**THE NETWORK RAIL (OLD OAK COMMON GREAT WESTERN MAINLINE TRACK
ACCESS) ORDER**

PROOF OF EVIDENCE

NICHOLAS GALLOP BSc

SUBMITTED ON BEHALF OF BELLAVIEW PROPERTIES LTD

Figure 1 Extract from NR09 showing RRAP and TPWS loop (extent of fouling highlighted)

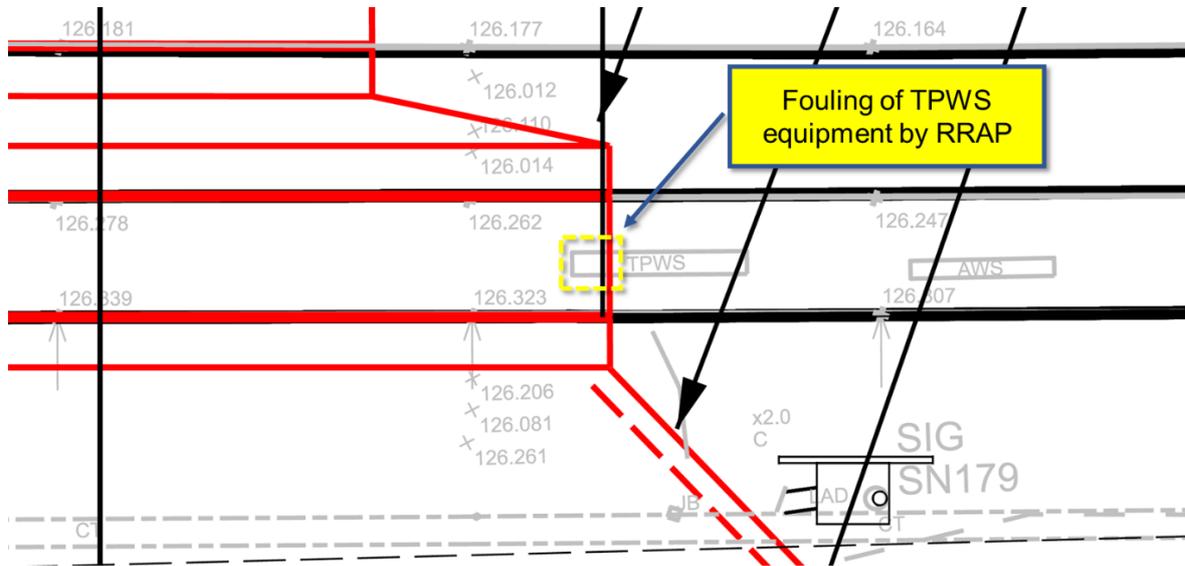
i) Drawing NR09 produced by Network Rail for the proposed temporary RRAP shows the eastern edge of the hardstanding across the rails fouling a critical part of the main line signalling system known as

the Train Protection Warning System (TPWS) as shown in Figure 1 below. In a standard installation there are two pairs of loop antennae located between the running rails, colloquially referred to as "grids" or "toast racks". Both pairs consist of an 'arming' and a 'trigger' loop. If the signal is at danger the loops will be energised. If the signal is clear, the loops will de-energise. Given the importance of these loops, it is important to site these away from any other fixed structures that might interfere with their safe operation. Contrary to the guidance in CD34, it is therefore a concern that the drawing presented shows the RRAP fouling this equipment;

- ii) Drawing NR09 also shows the northern edge of the RRAP in close proximity to Acton Main Line station platform. The RRVs will have to come onto the RRAP with the rail undercarriage retracted before turning 90° to face the direction of travel on either of the Main Lines before deploying the rail wheels. A general arrangement drawing showing a section through the temporary RRAP has been produced and is attached at Appendix R, for a typical RRV which might be expected to use the facility (other RRV designs may be longer or shorter than this). If the RRV as shown attempted to centre itself on the GWML Up Main Line nearest the island platform at Acton Main Line station in order to perform the 90° manoeuvre, the RRV would collide with the edge of the platform. Contrary to the guidance in CD34, it is therefore a concern that the drawing presented could result in RRV fouling a lineside structure;
